# GENERAL GUIDELINES FOR HSR IN FRESNO

The design of elevated structures and bridges will be a key element in the overall image of high speed rail as it passes through Fresno. These very visible elements should be coordinated with one another in Fresno, and with the rest of the system throughout the state.

**Figure 2-8**  
Elevated Structure Typical Cross Sections

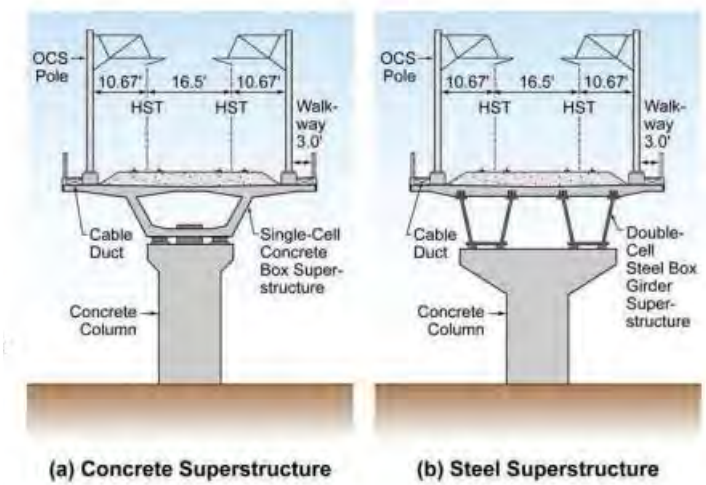
The typical elevated portion of the alignment throughout much of the state-wide alignment and portions of Fresno is a single or twin box girder structure on single, flared piers. As indicated in the Concept Approach to HSR Design above and building on the CHSRA Architectural Guidelines, the recommended aesthetic design is aerodynamic, monolithic and curved/softened edges. The primary components are piers, a flared box section, deck overhangs with parapet type edge barriers and twin OCS poles. Steel superstructure box girder options may require additional work with deck and pier top to create a smooth relationship between pier and flared girders.

**Recommendations: aerodynamic forms; curved edges; monolithic surfaces.**

15% Engineering Drawings: Typical straddle bent design concept

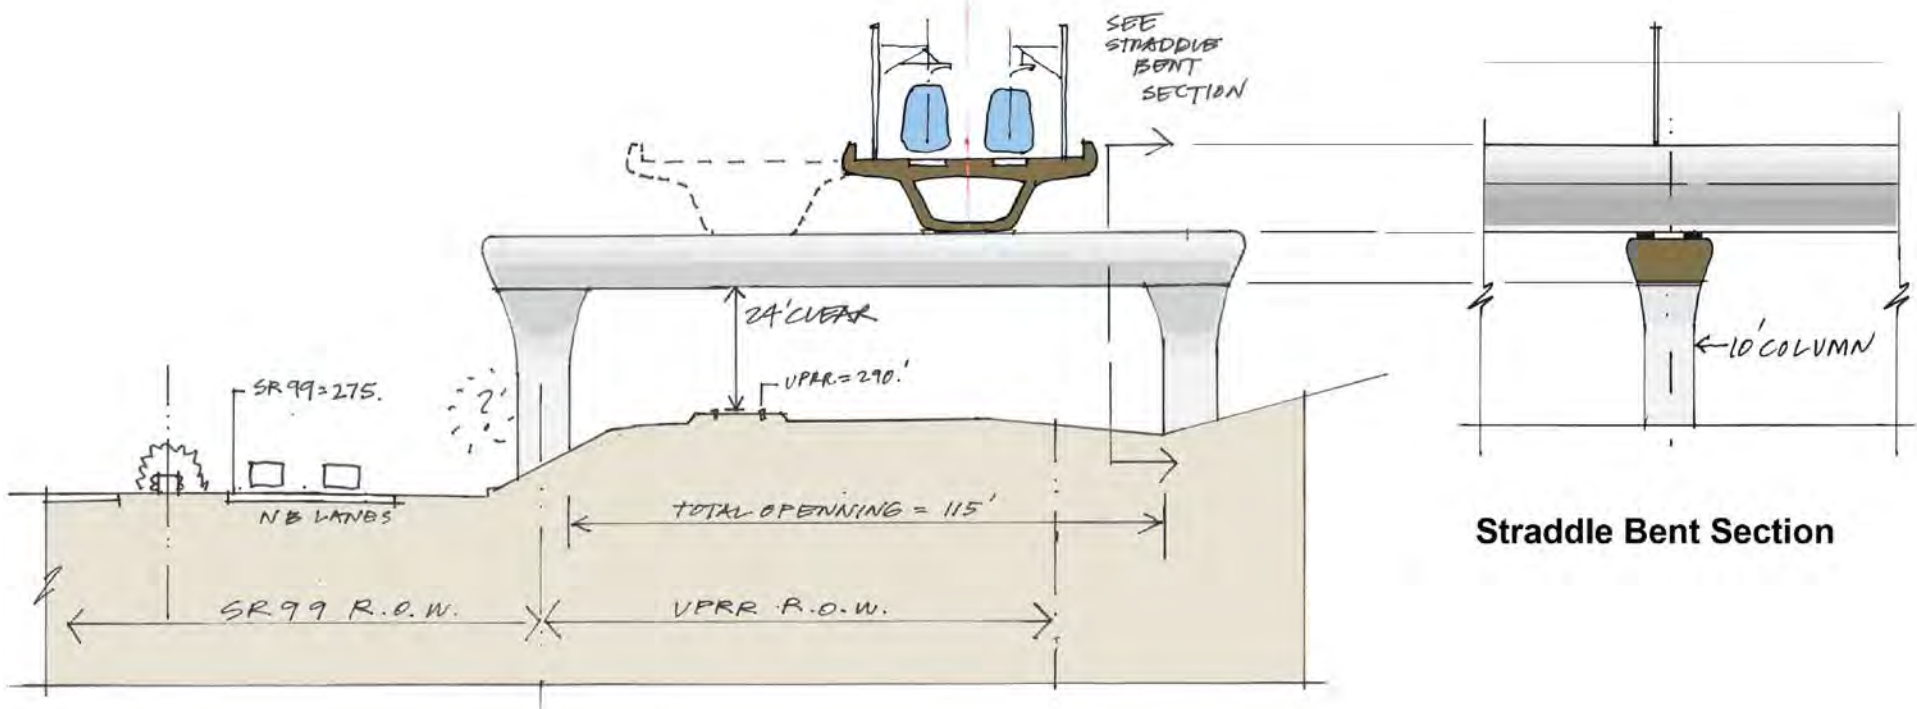
Our recommendation is that straddle bents follow the same aesthetic guidelines applied to the general guideway: twin piers of the same flared form as the single, center pier, joined by a robust beam with curved edges and ends and cross section that approximate the flare of the piers. In order to convey the uniform and smooth appearance, integrated bents are preferred over composite bents. This will give a continuous line to both structures and keep straddle bents in the unified family of forms.

Recommendation: Curved, smooth saddle bents to match the speed and design of HSR vehicles.

**Figure 2-29**

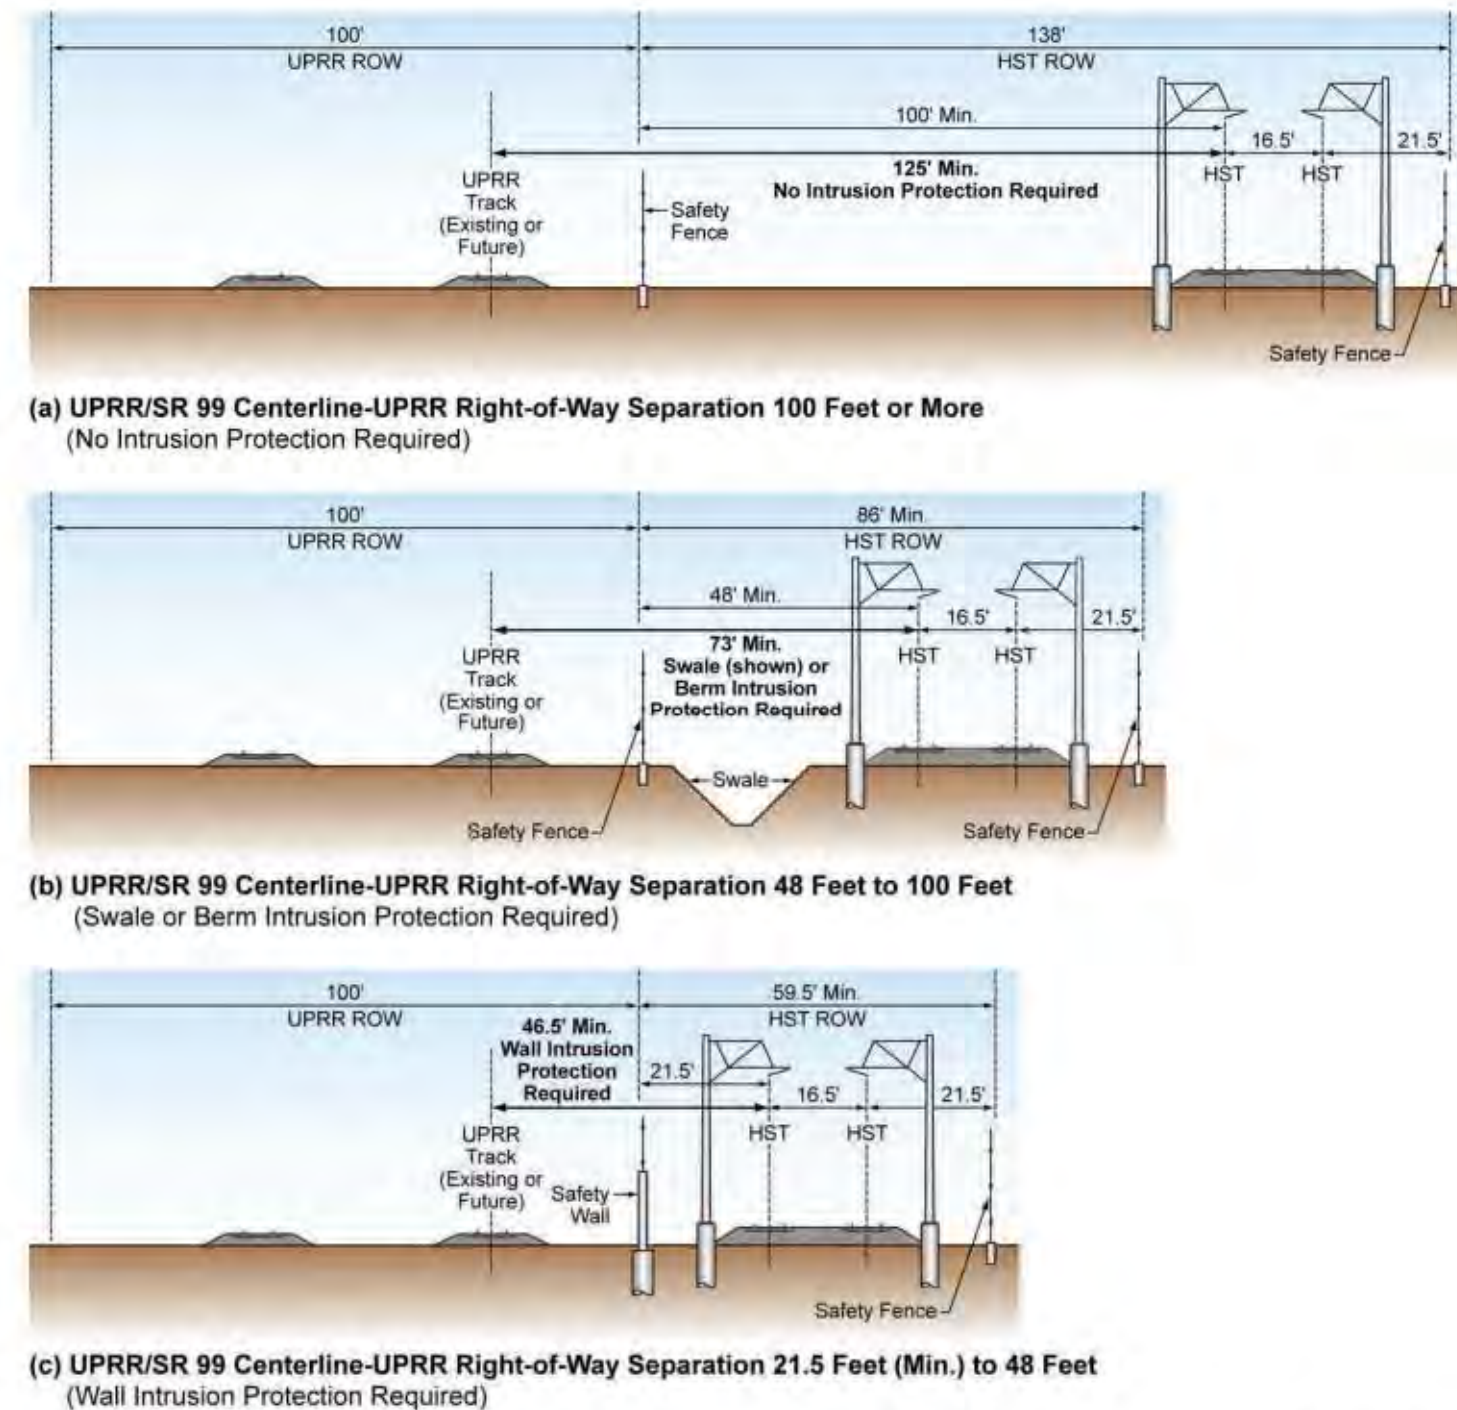
**Similar to the other cast-in-place (CIP) or MSE walls of the project (see CHSR Typical Treatments), the Intrusion Barrier Wall should use a fractured fin texture, supplemented by an architectural jointing system corresponding to construction joints vertically and horizontally and a pre-determined module. At street crossings where the Intrusion Barrier Wall is most visible, an opportunity exists for site specific, commissioned, art projects.**

**Figure 2-7a**  
Retained Fill Typical Cross Section

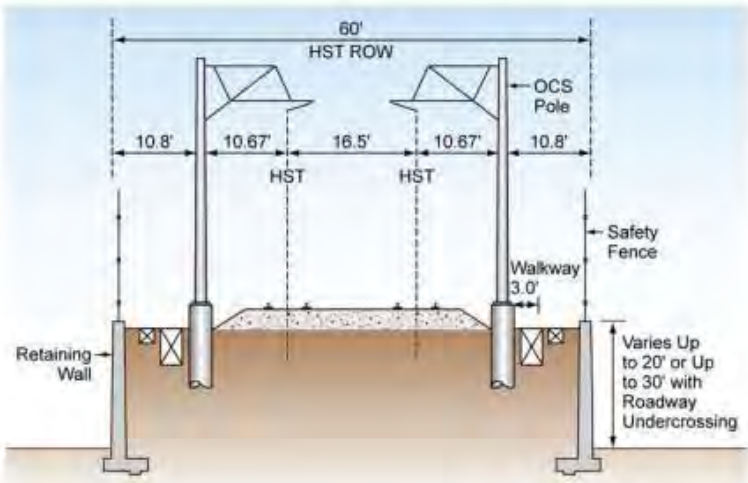
- MSE Fill walls: typical required elements are cast-in-place corner pilasters (unless special corner pieces are available) and a cast in place wall cap/railing or barrier foundation. The independent design team recommends the combined wall cap/parapet type barriers be designed to look similar to the parapet barriers in the HSR guideway.
- Cast-in-place (CIP) Fill walls: a fractured fin texture can be supplemented by an architectural jointing system corresponding to construction joints vertically and horizontally and a pre-determined module. The parapet barrier can be integral with the wall top since it does not have to cover the tops of saw-cut MSE panels.
- Fill wall visual impact can be reduced by using landscape berms to diminish the amount of wall surface shown. Berms should use xeriscape (desert/drought-resistant) landscape for erosion control.

**Recommendations: fractured fin concrete wall texture; coordinated joint pattern; concrete cap at MSE options; finished wall top at CIP options; integrate design of wall top with other elements such as railing, lights and sign bridge mounts.**

**Figure 2-7b**  
Retained Cut Typical Cross Section

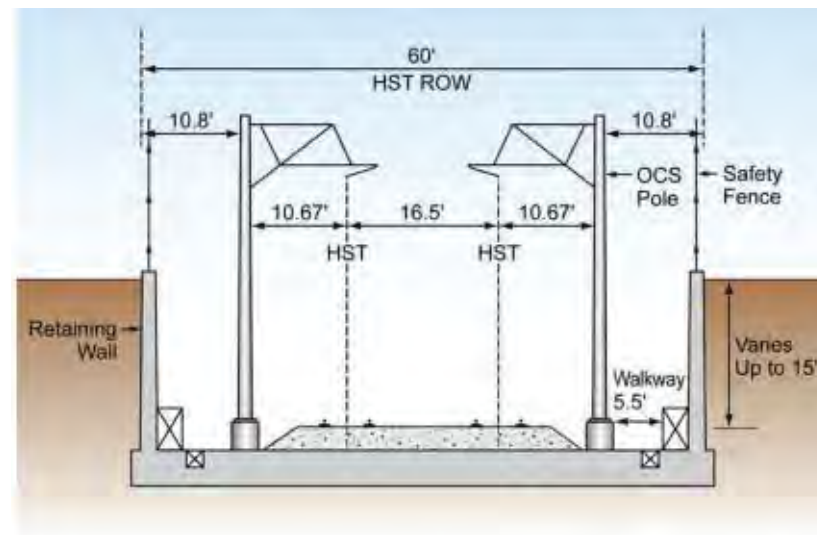
Trench/Cut Walls will likely be cast-in-place construction using technologies to mitigate excavation for tie backs and water table. Similar broken fin texture and jointing modules should be applied. In some cases the wall top may be a vehicular parapet type barrier. In other cases, the wall top will include a pedestrian-only railing. The module of railing sections, light poles and wall joints should be coordinated to achieve architectural resolution between all elements.

**Recommendation: broken fin texture; modular jointing; coordinate jointing with railing and light fixture spacing; refer to general recommendations for downtown undercrossings on page 6.**
